Car Stereo  
**Service Bulletin**

**CSA-14**

**Model:** MDX-U1

**Subject:** No Operation

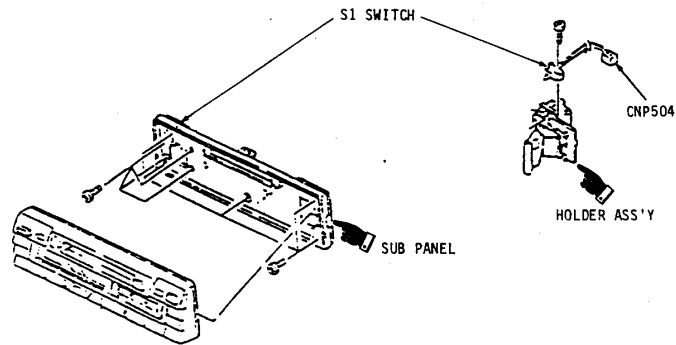
There is no display and the unit does not respond to any of the function buttons.

**Solution:** Replace S1 and the sub panel as shown below.

Applicable serial numbers: 10,001 to 10,900 (replace switch and sub panel)

10,901 to 11,700 (replace switch only)
